VALLEY VIEW LOCAL SCHOOLS
Germantown, Ohio

Addendum No. 1

BOARD OFFICE RENOVATION PROJECT

Prepared by:
The Oregon Group Architects
300 S. Patterson Blvd.
Dayton, Ohio 45402
937-228-1511
Kyle Zepernick
kzepernick@oregongroup.com

a typical saw cut detail

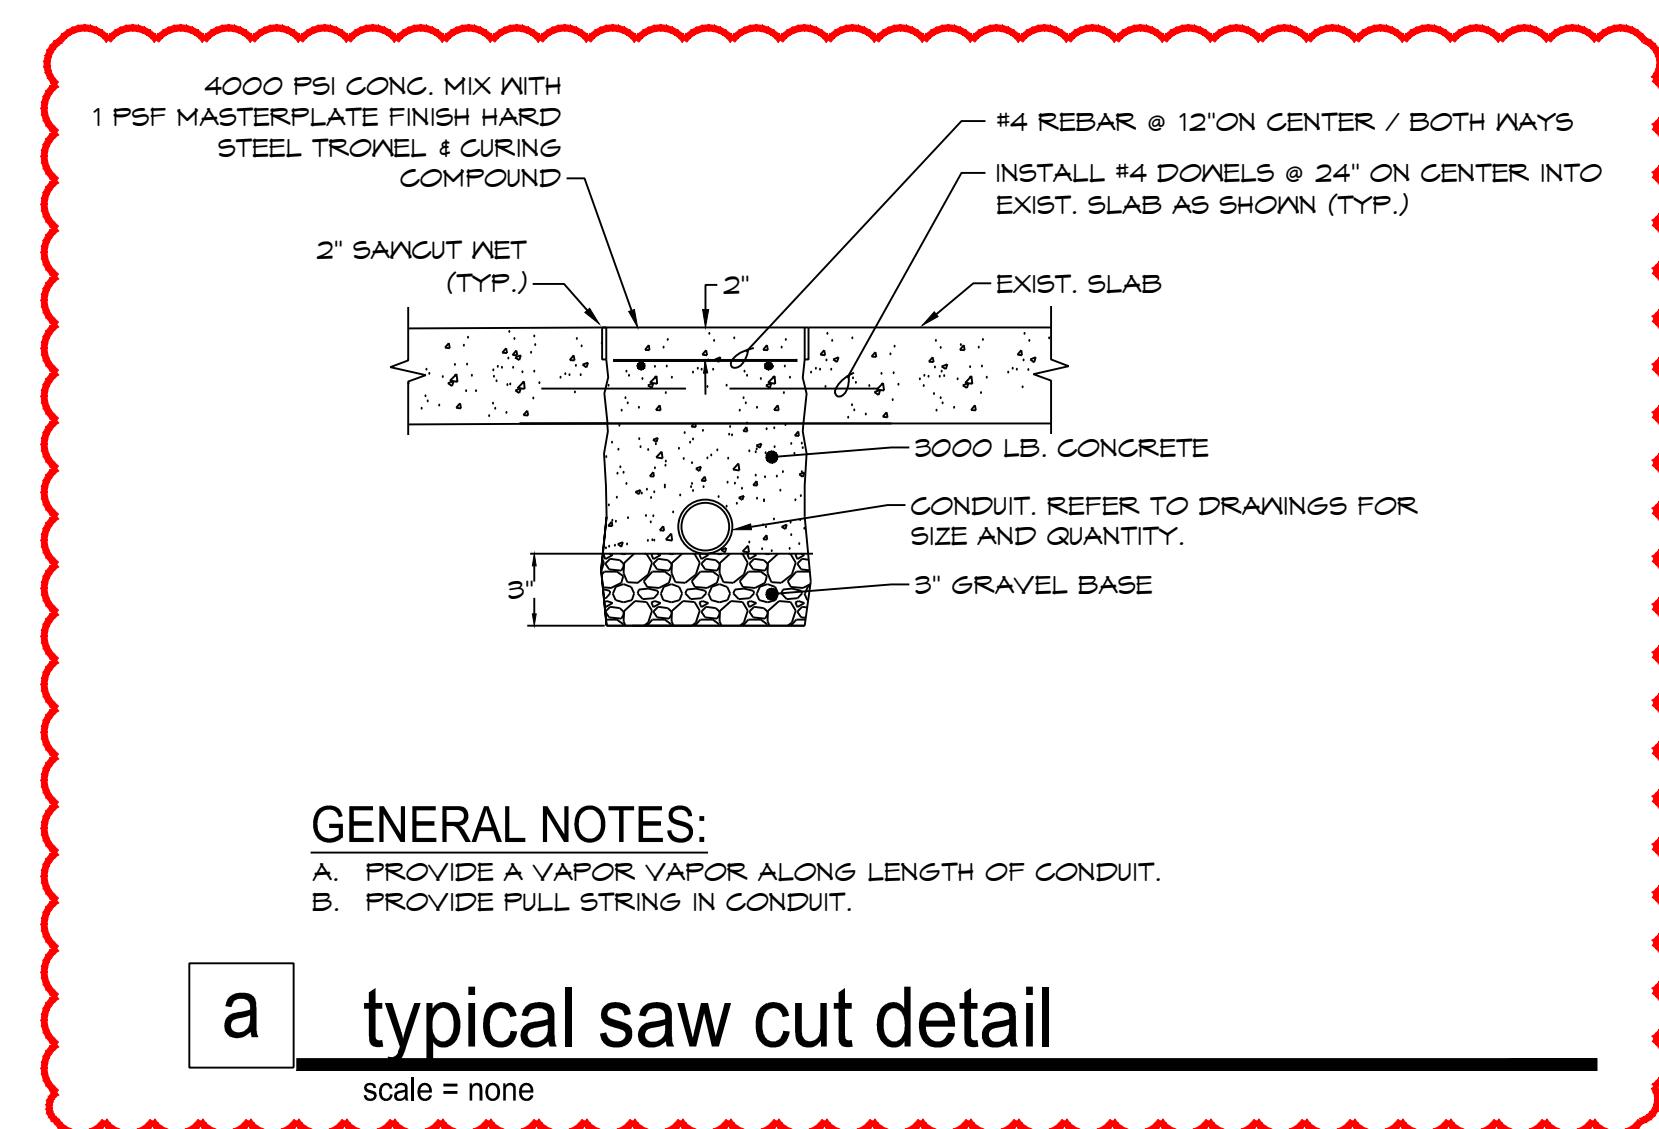
Item No. 9: Sheet A1.2, new Detail a/A1.2 for concrete slab repairs at floor trenches. Repair detail would be applicable to all floor slab trench repairs.

b #110 unisex / #111 unisex plan 1

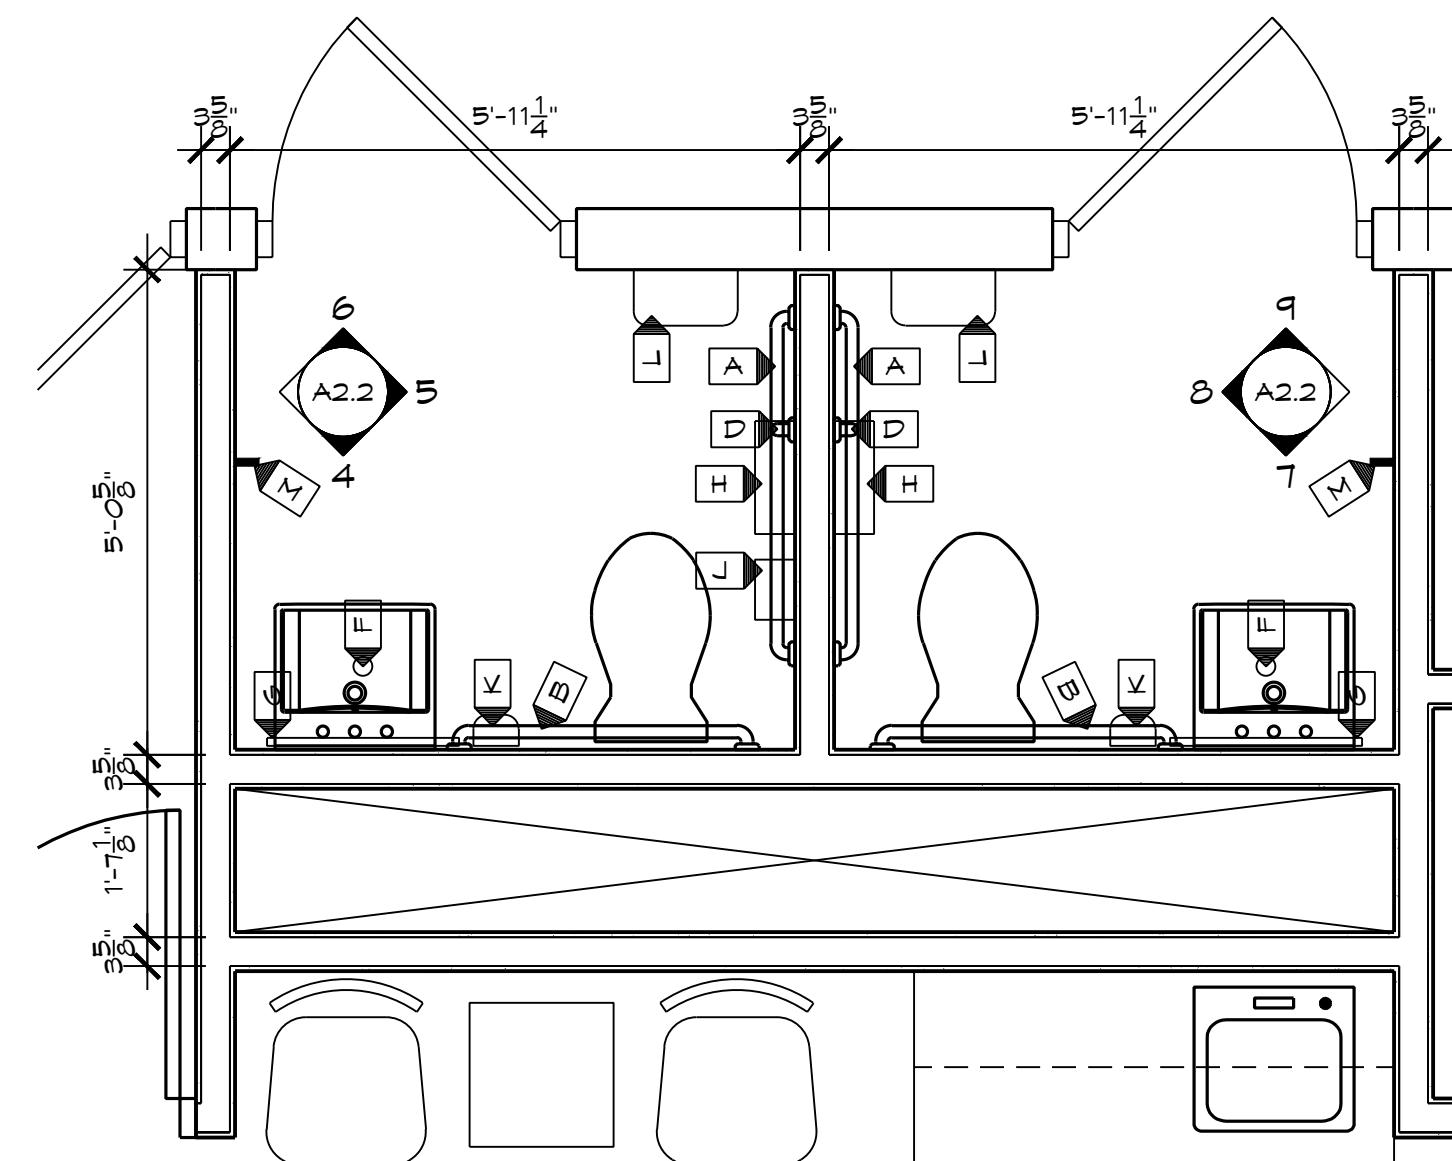
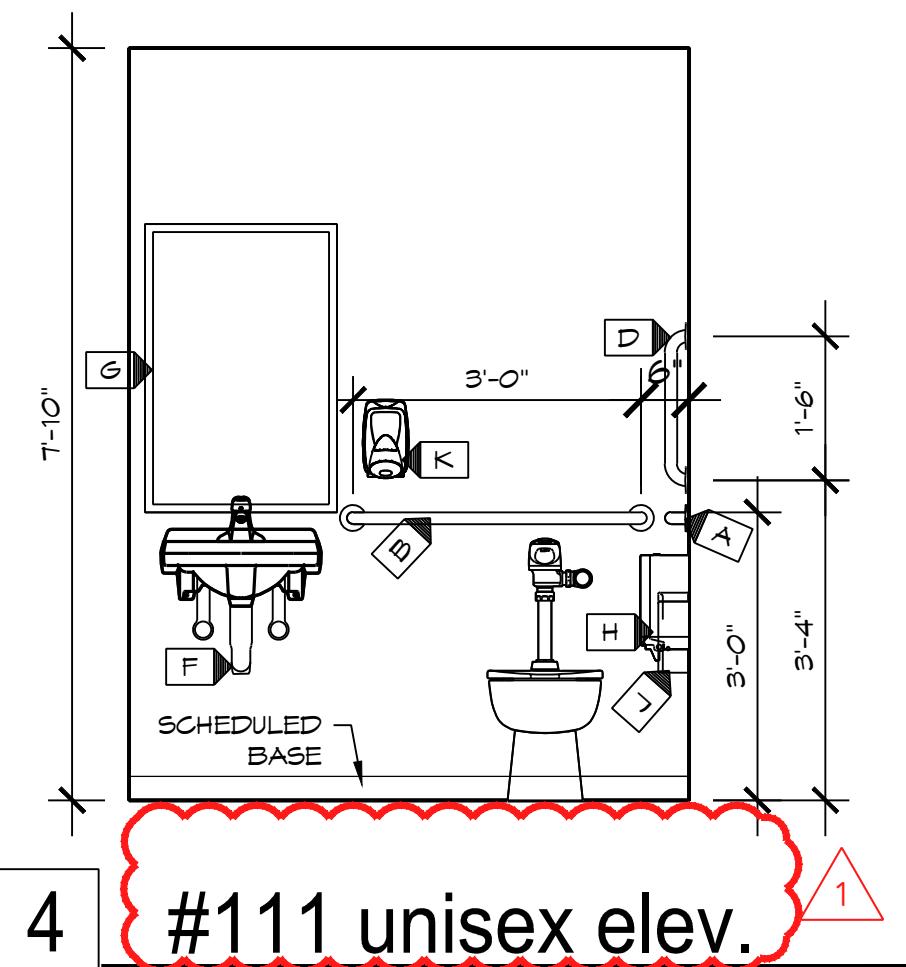
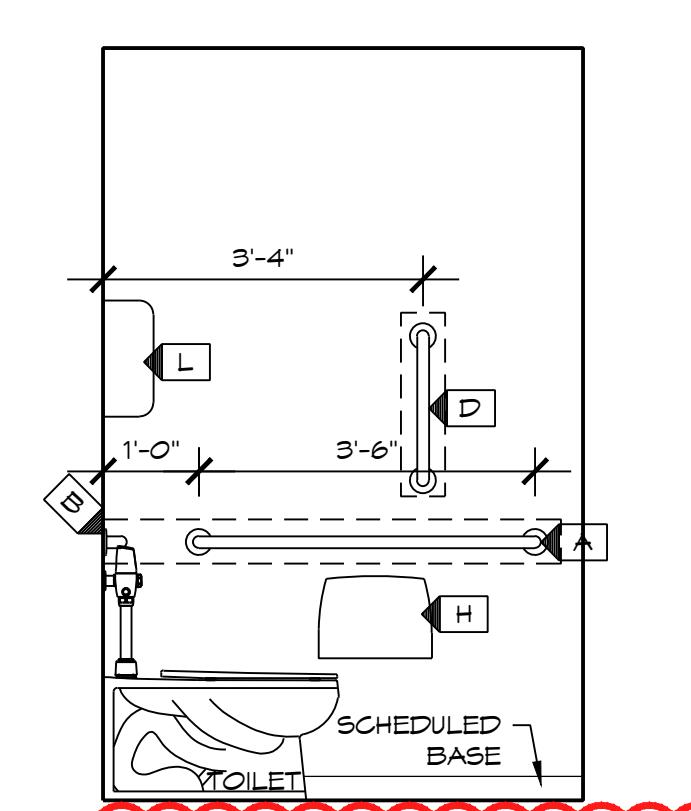
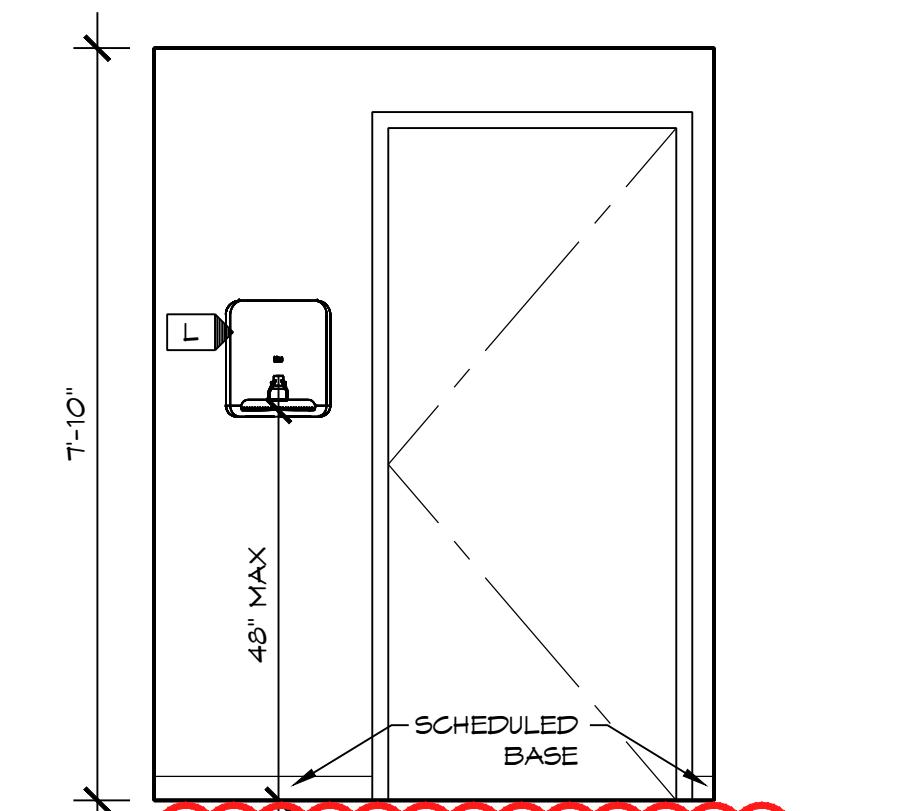
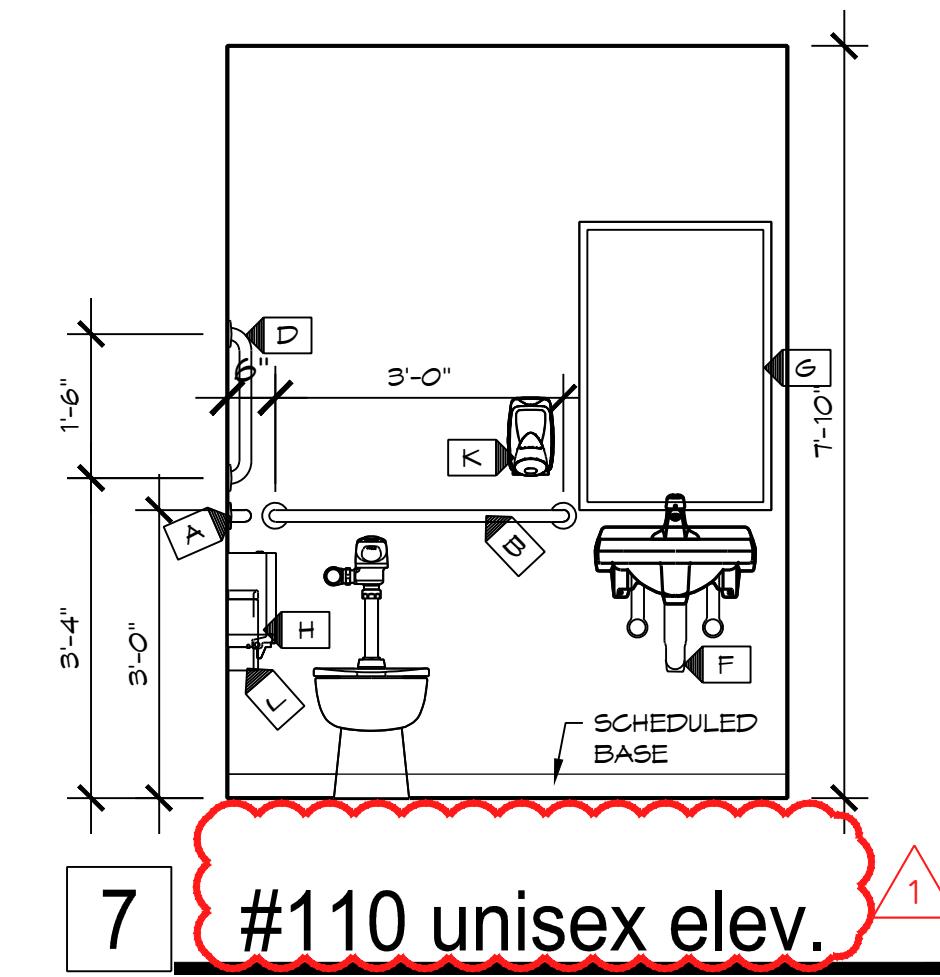
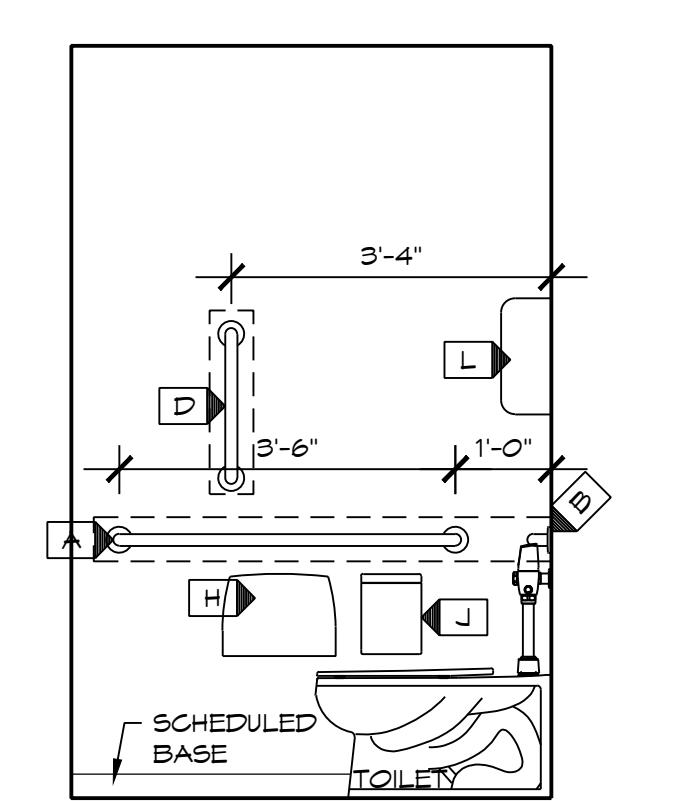
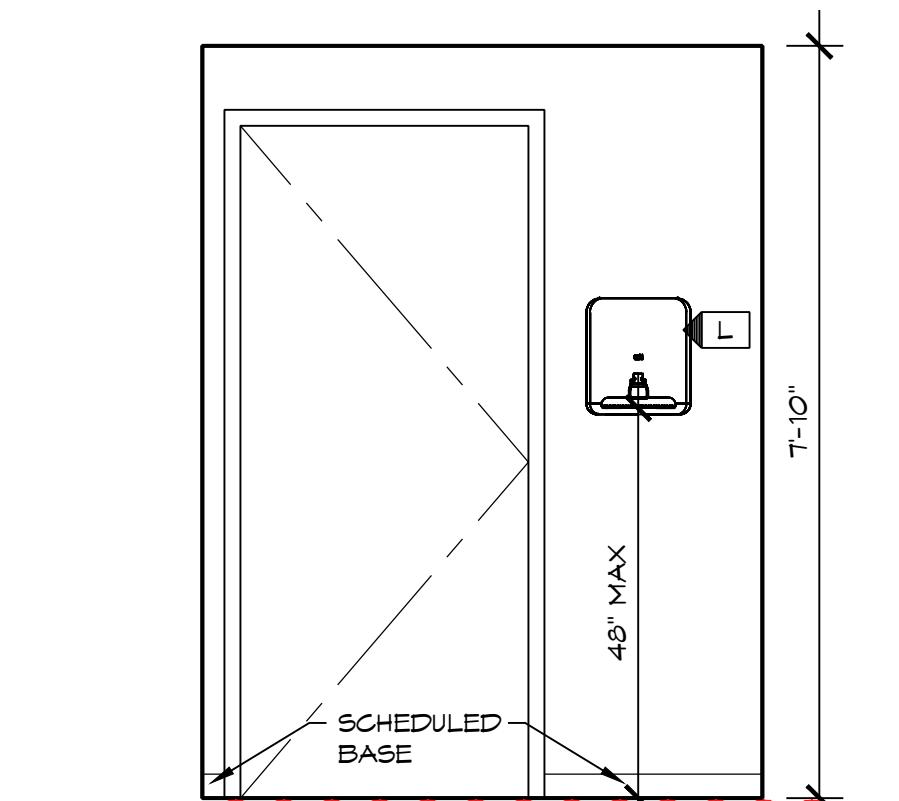
Item No. 5: Sheet A1.3 Room Signage – Room signs at Toilet Room 117, Restrooms 110 & 111 should read “Unisex” and have both men and women’s pictograms. See attached revised Drawing Sheet. A1.3.

2b jamb detail

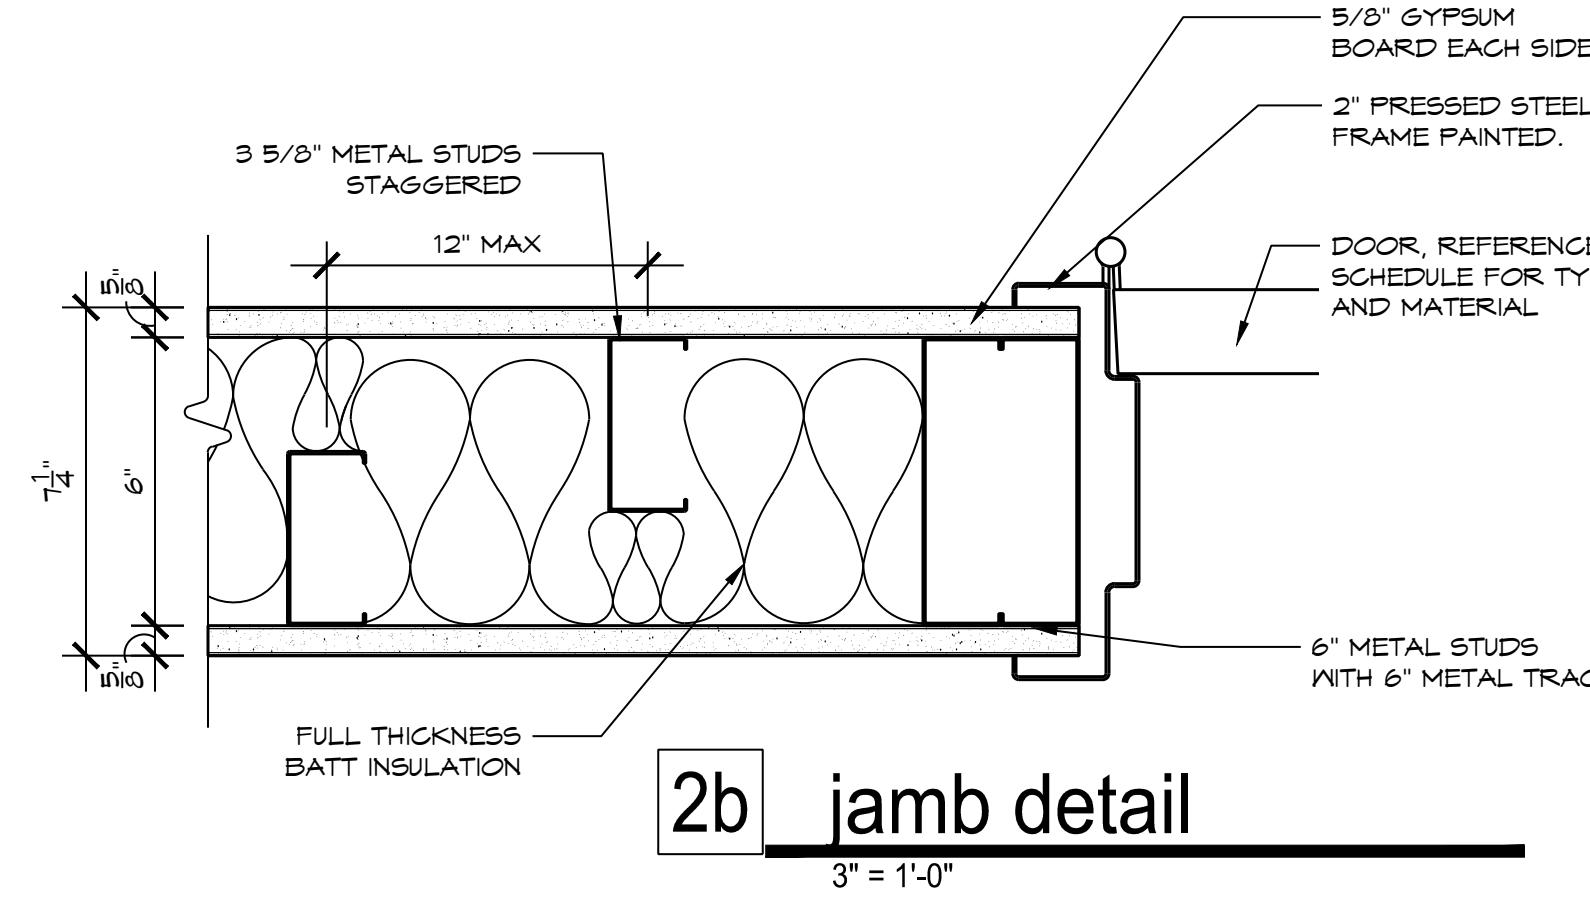
Item No. 7: Sheet A1.3, New Work Note #2. Add to note that double stud wall is detailed on Detail 2b/A3.1. See attached revised Drawing Sheet. A1.3.
